Gateway Review: 30-46 Auburn Road, Regents Park

27 November 2020
IPC Briefing

Council's Position

FSR Control Rationale

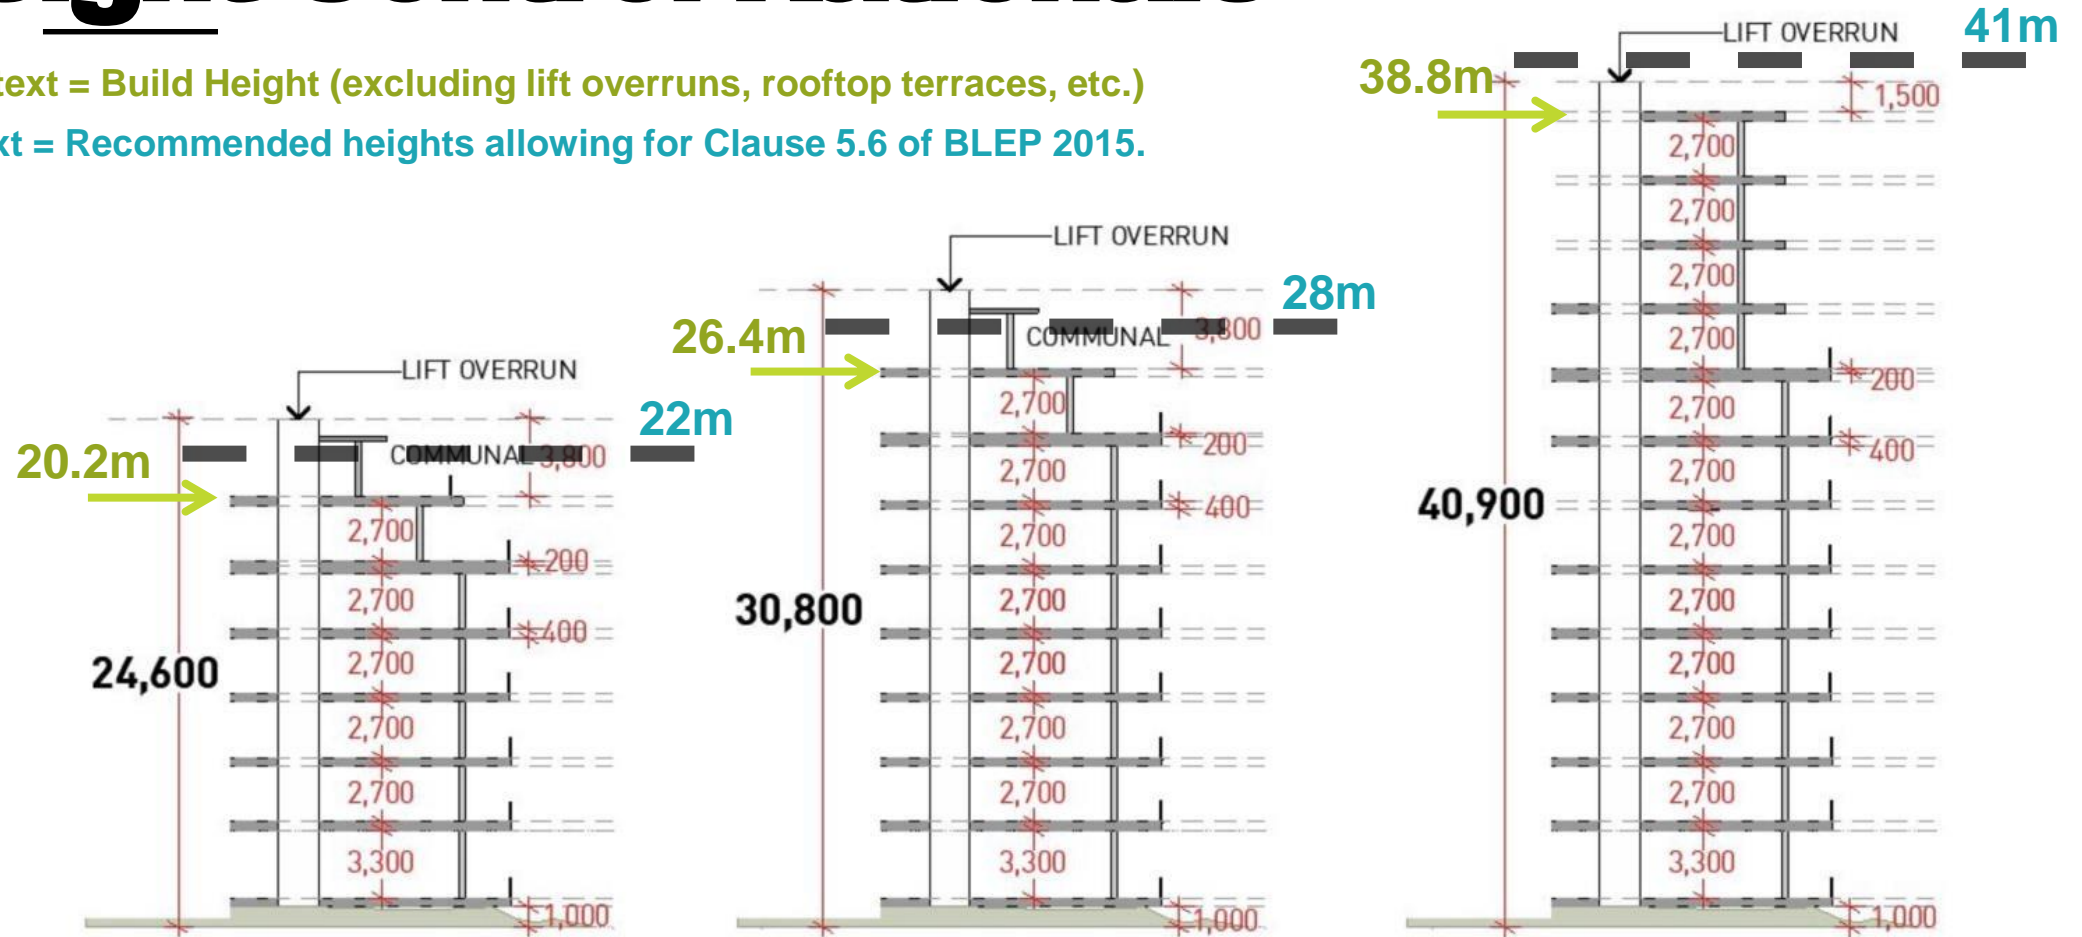
- **Other FSR's** proposed:
 - Are **inconsistent** with the strategic and site-specific merit test for all planning proposals.
 - Create solar access issues to be resolved at the DA stage due to inclusion of a 12 storey element.
- **Council's** supports the recommended FSR of **1.75:1** as it is:
 - **consistent** with the strategic and site-specific merit test.
 - Supports appropriate setbacks
 - ADG Solar Access requirements is should be achievable.

ELEVATION - AUBURN ROAD (EAST)

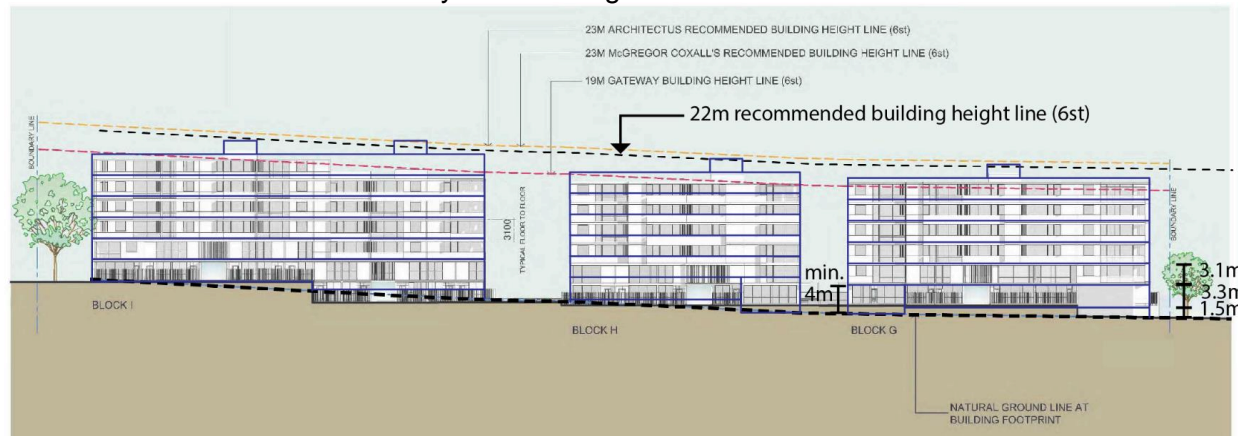
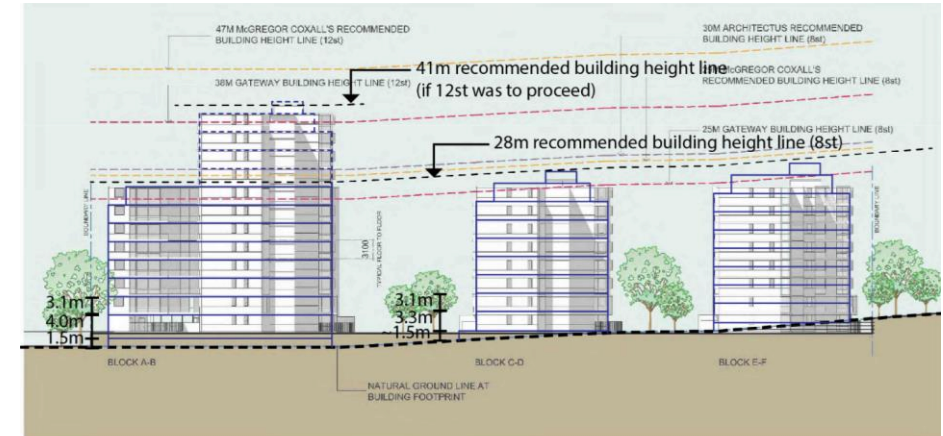
- Disagrees with 12 storey maximum as this is outside the range of heights for similar areas in the LGA and would have undesirable view and overshadowing impacts

Figure (left): Proponent's scheme (Studio MRA – August 2020) with Council's setbacks. Source: Attachment M, DPIE Review, November 2020

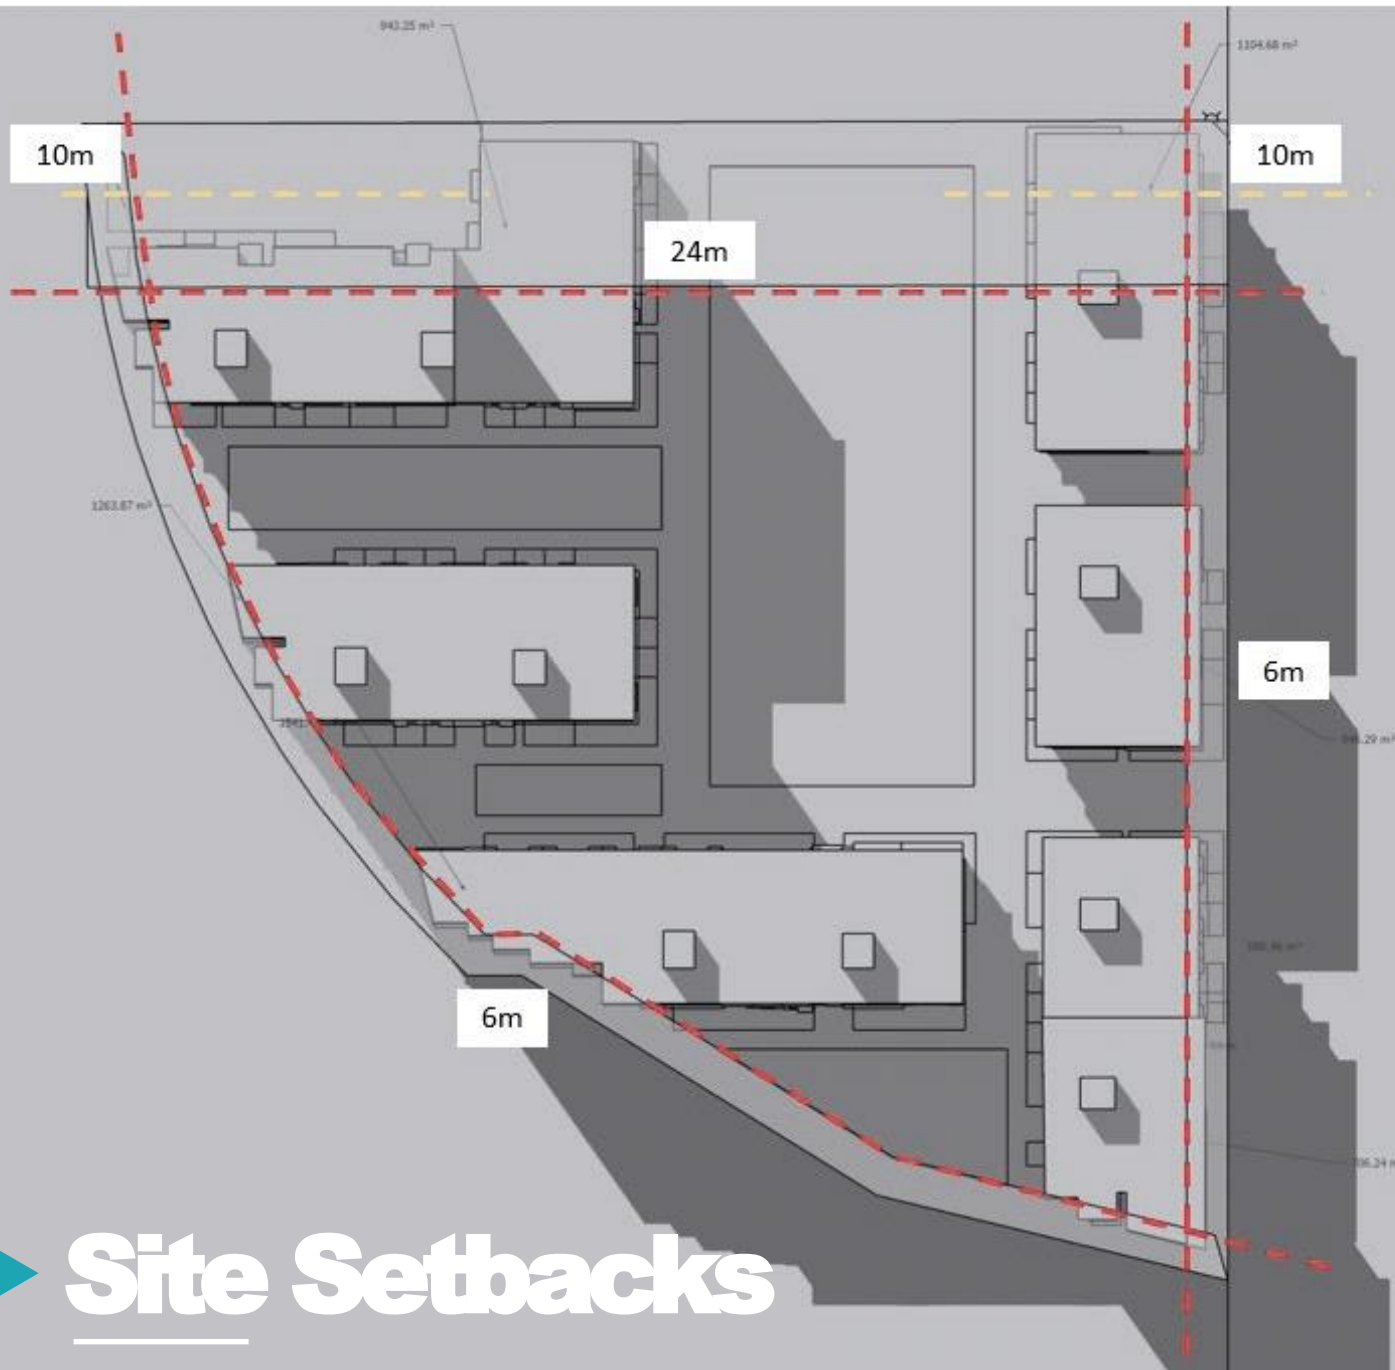
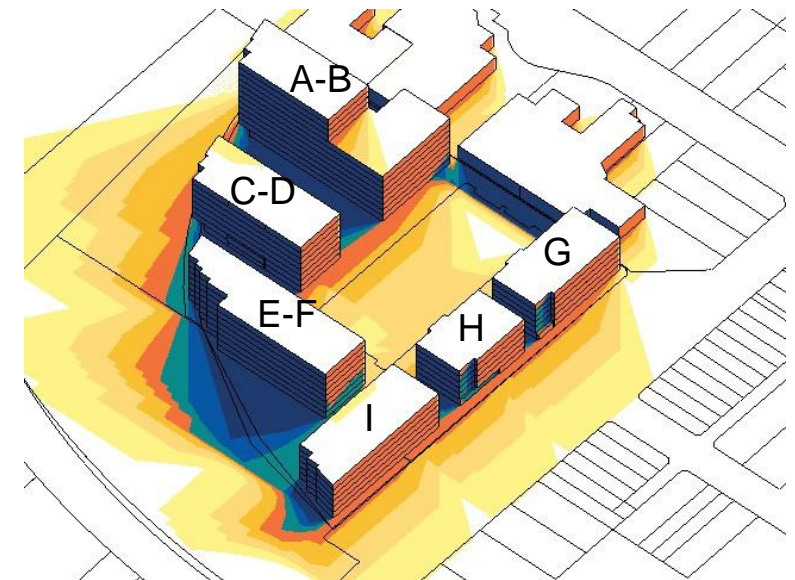
- maintain appropriate amenity protection from adjacent land uses (ie, industrial, rail and major road),
- Allow for deep soil planting and shared cycle paths.
- The lack of appropriate setbacks, residential amenity impacts and overall building bulk suggests the building footprint coverage is too large for the site.

Source: Solar access map, 9am to 3pm mid-winter, prepared by Smith & Tzannes in their peer review, dated August 2020

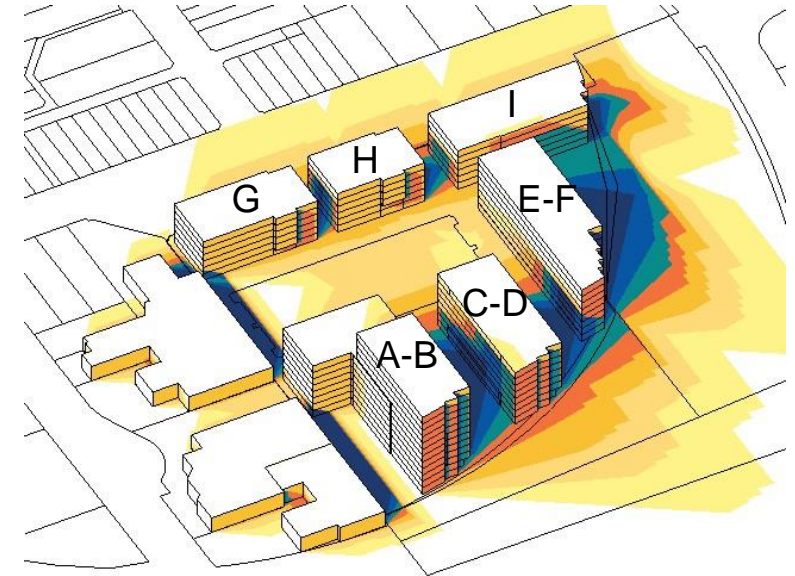
- ADG quite clear on individual ‘building’ approach to solar analysis, not collectively as advised by the Proponent.
- Buildings A-B, C-D and E-F **fail to comply** individually with the maximum 15% requirement in a building receiving no sun (ADG objective 4A-1.3).
- In addition, buildings C-D and E-F **also fail to comply individually with the minimum 70% of apartments** receiving at least 2 hour direct sunlight between 9am-3pm mid winter (ADG objective 4A-1.1)

Length of building, natural ventilation & footprint coverage

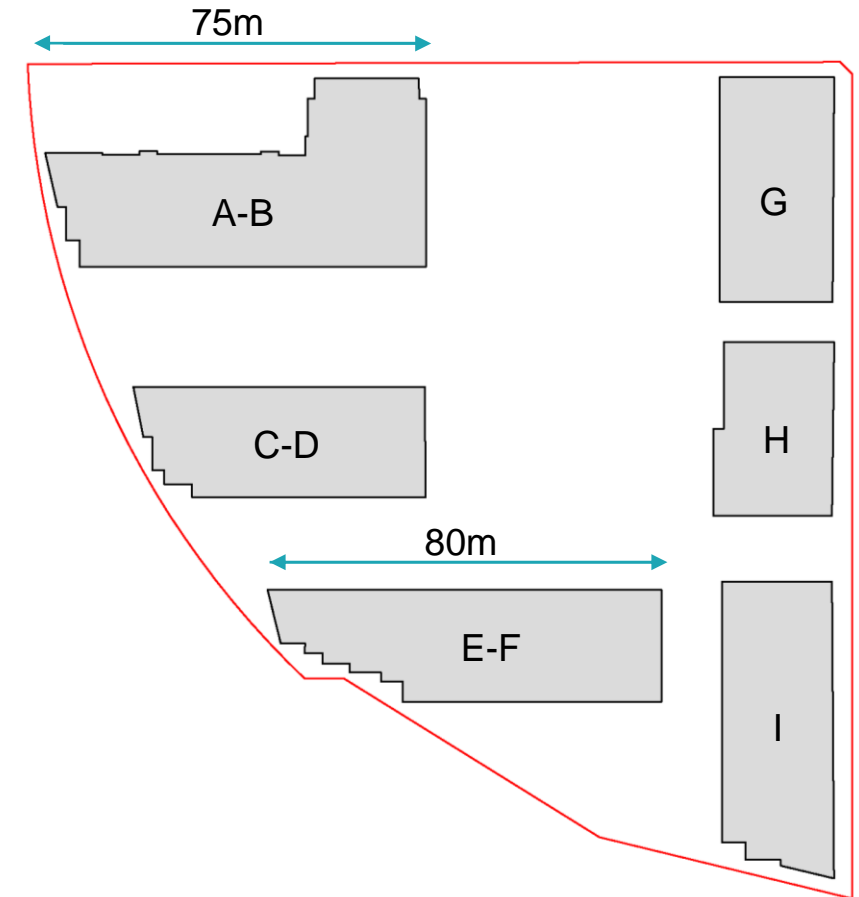
- Generally buildings longer than 60m length as its difficult to:
 - Cross ventilate (long corridors, single sided units)
 - Solar access
- Buildings A-B and E-F exceed 60m in length (75-80m long)
- Conflict between acoustics and cross ventilation outcomes adjacent to the rail line to achieve ADG requirement will be difficult with existing design.
- Excessive footprint site coverage and building length exacerbates solar access issues, natural ventilation and visual bulk.

Access and address

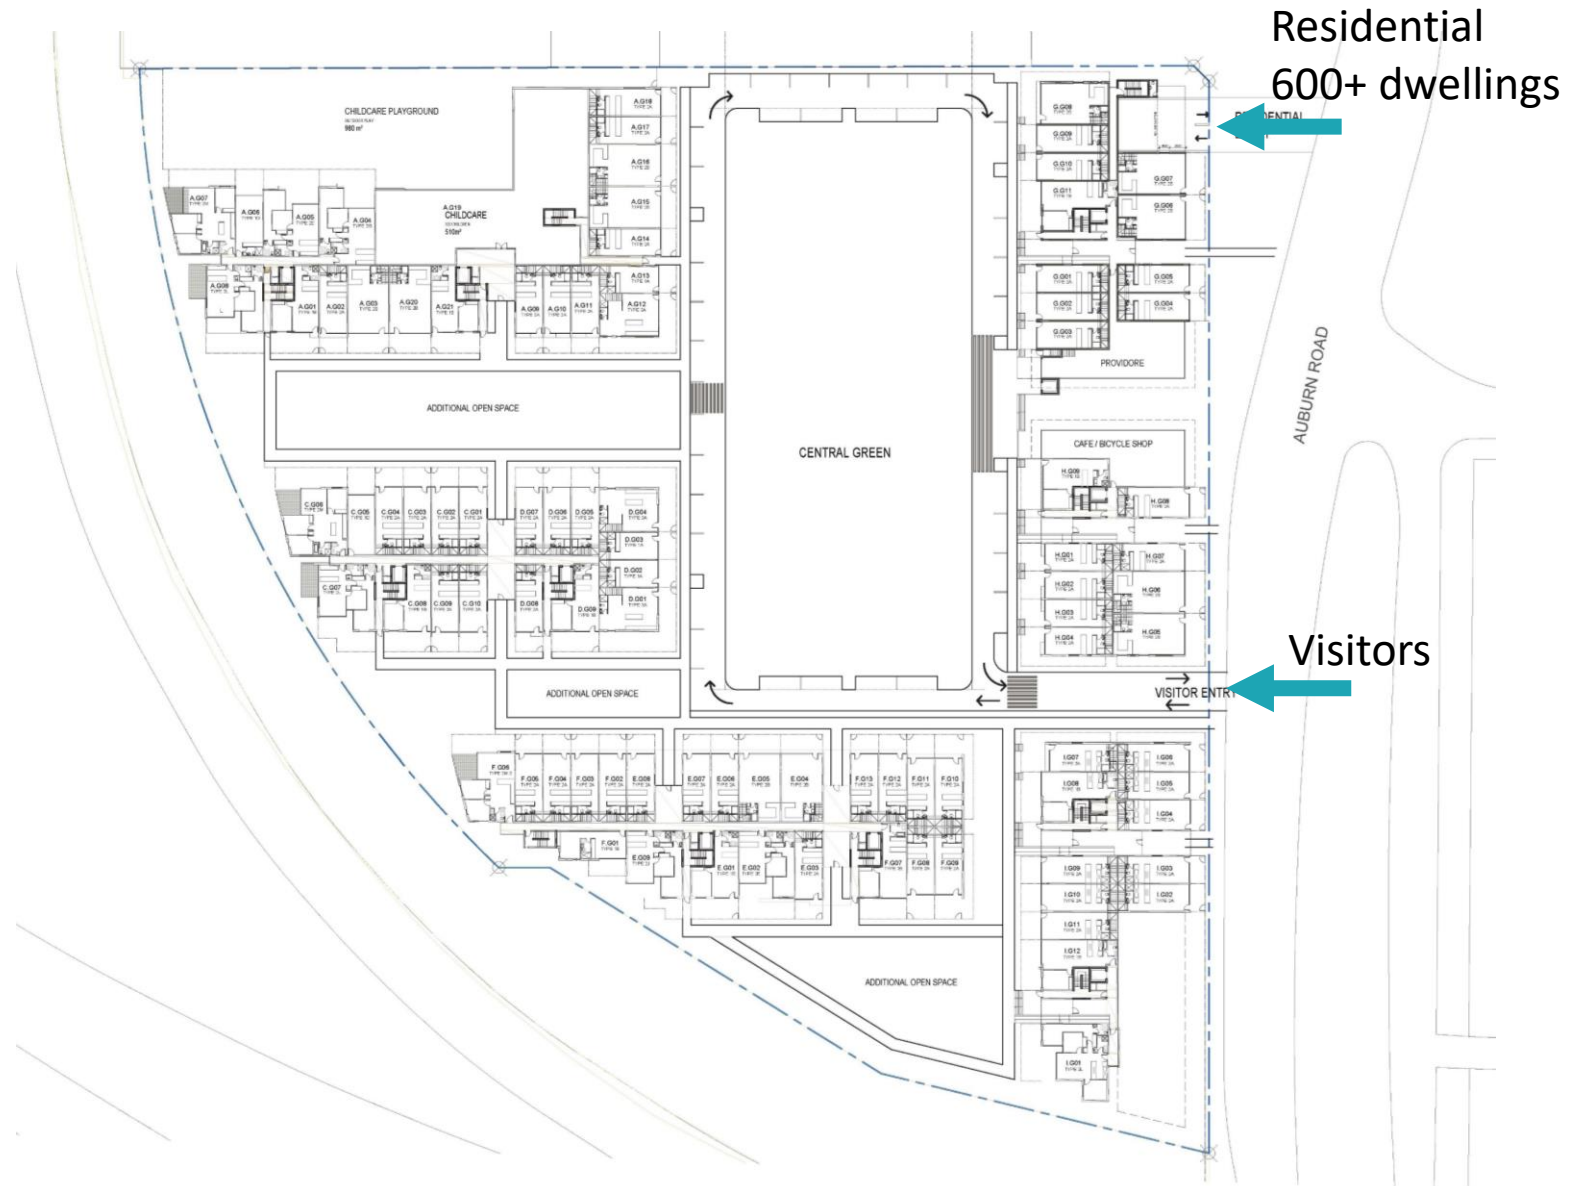
- Limited access of Auburn Road
- Limits the ability to stitch into the local neighbourhood and create a new 'block' pattern to support future development.
- Lack of clear address – especially to the Western Buildings.
